REMARKS

This Amendment is in full and timely reply to the Office Action mailed November 7, 2006. The applicant notes with appreciation that receipt of priority documents and consideration of the Information Disclosure Statement submitted June 2, 2004 have been acknowledged by the examiner.

Dated: April 4, 2007

FIG. 9

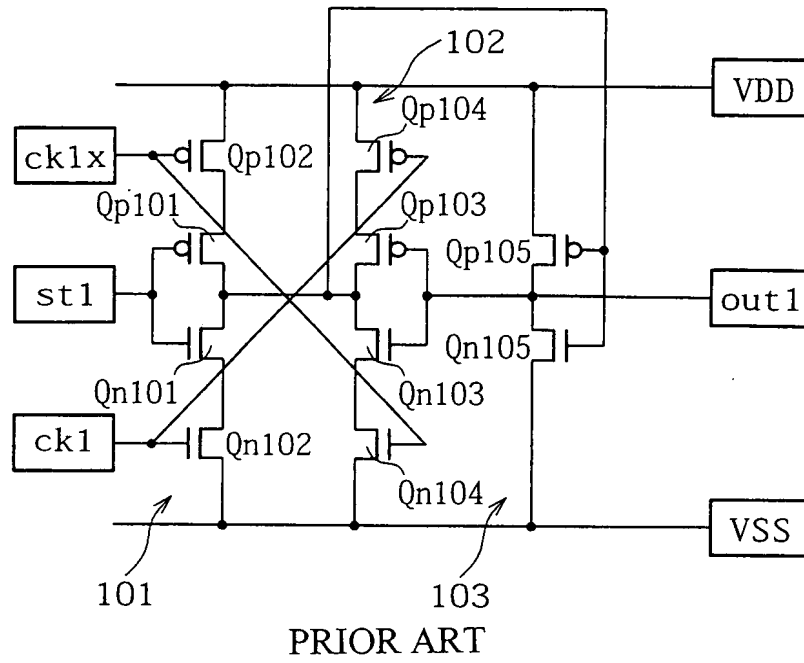
Figs. 9 and 10 have been amended to include the legend "PRIOR ART" as requested in the November 7 Office action. Additionally, Fig. 9 has been amended to correct slight drafting errors. No new matter has been added by these amendments.
